RCSC Middle School **Natatorium HVAC & Lighting Upgrade**

Project # 2023.0011

05-20-2024

ADDENDUM NO. 01

TITLE
Reflected Ceiling / Roof Demolition Plan
SHEET

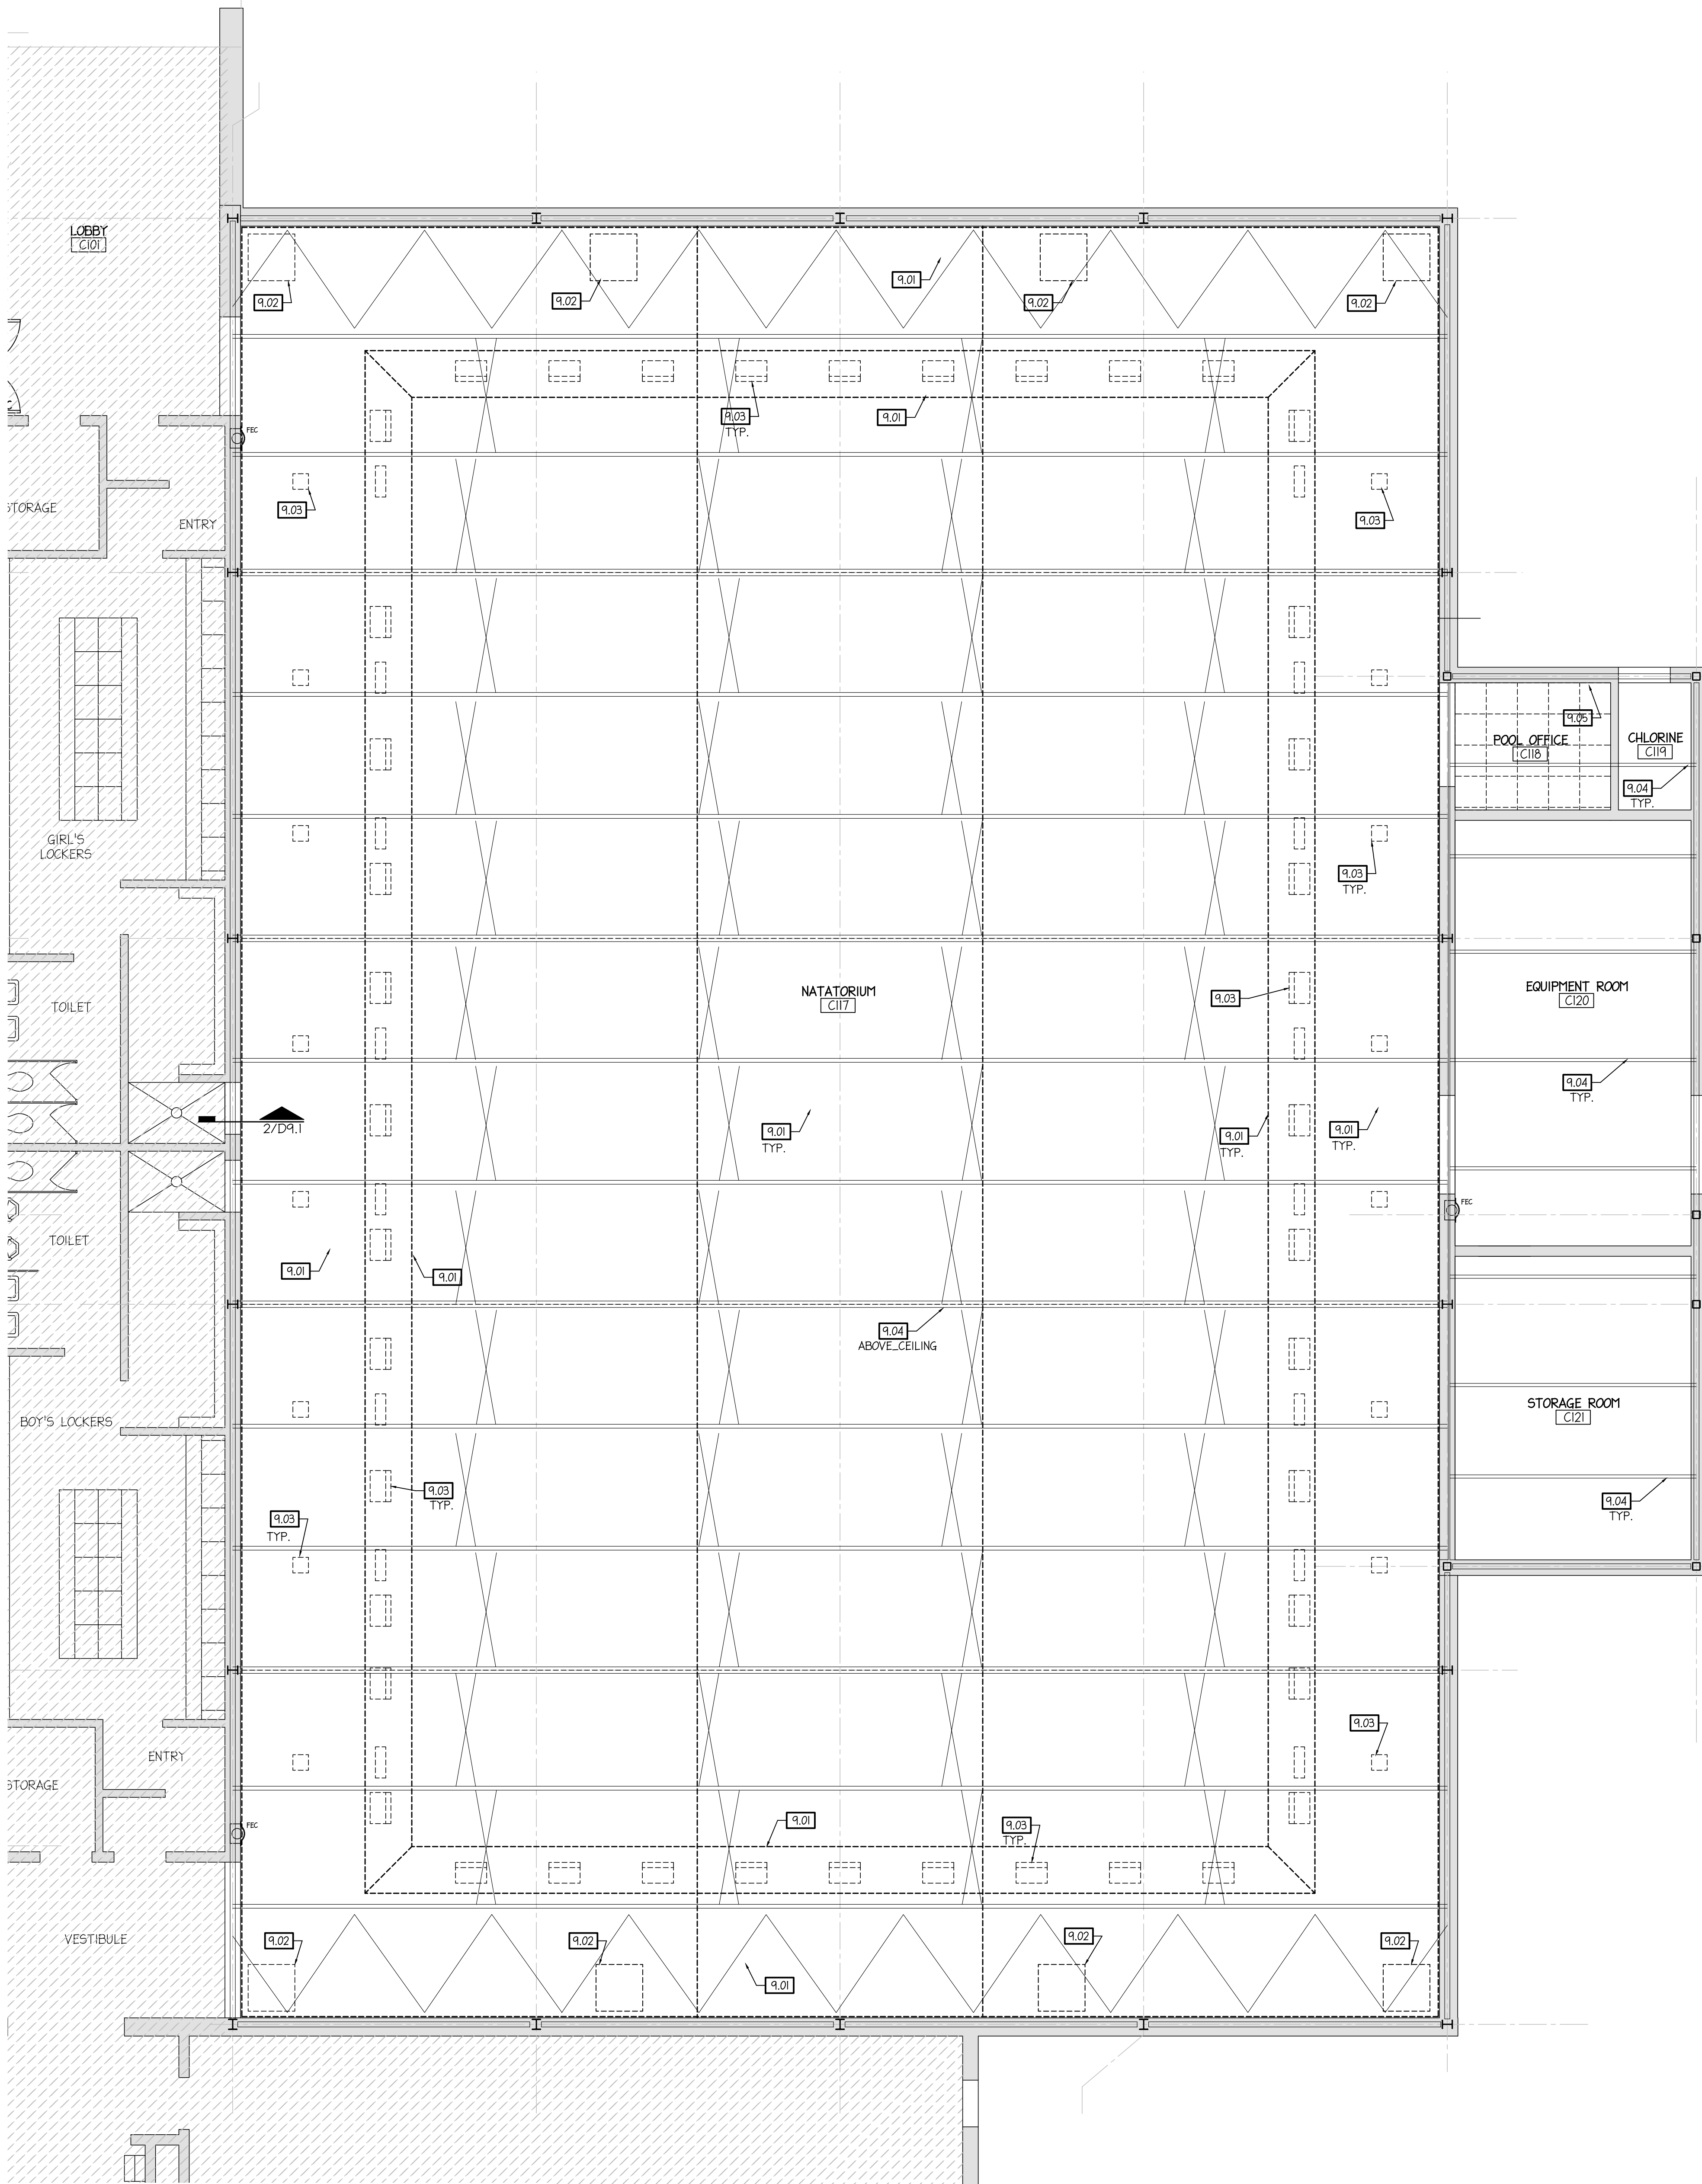
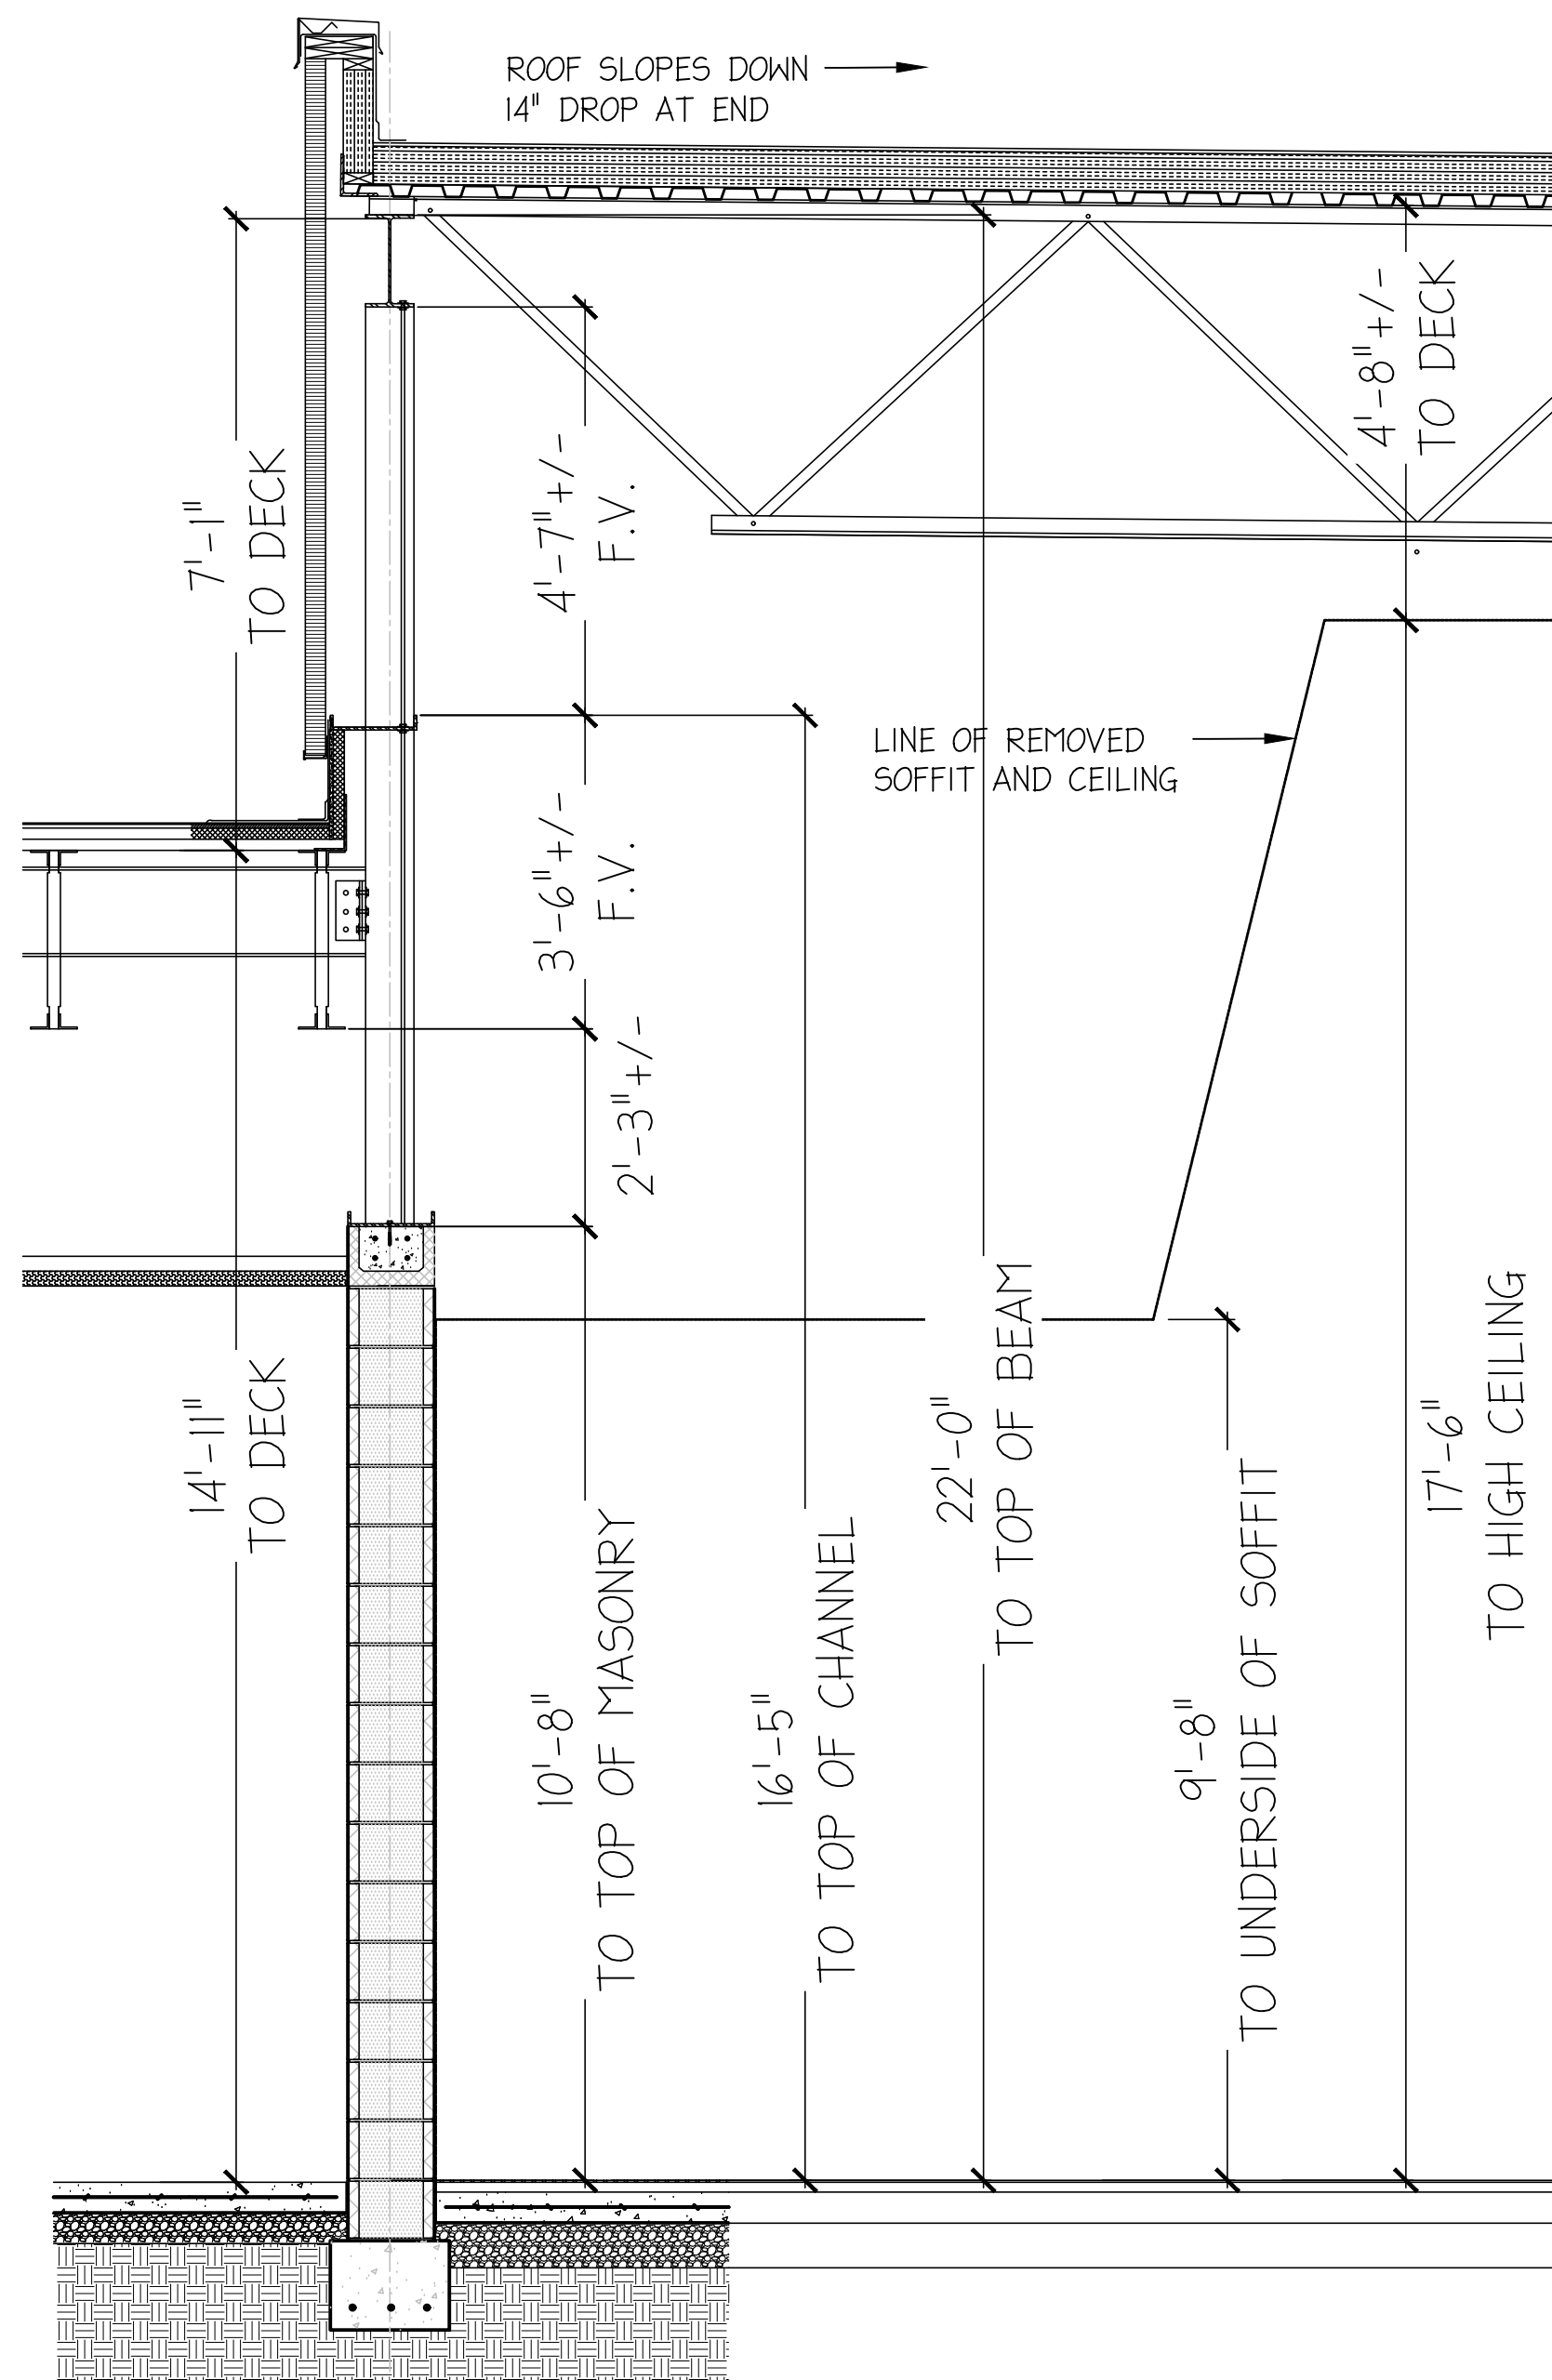
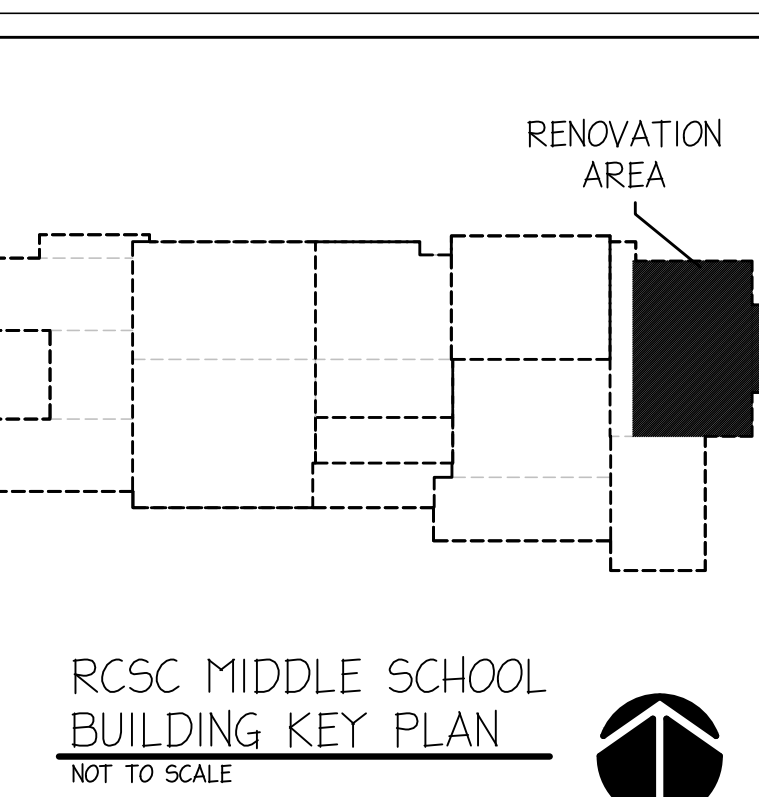
Location: D9.1 Reflected Ceiling / Roof Demolition Plan

1. Make note of warranty information about the existing roof in box note.
2. Added section detail 2 / D9.1.
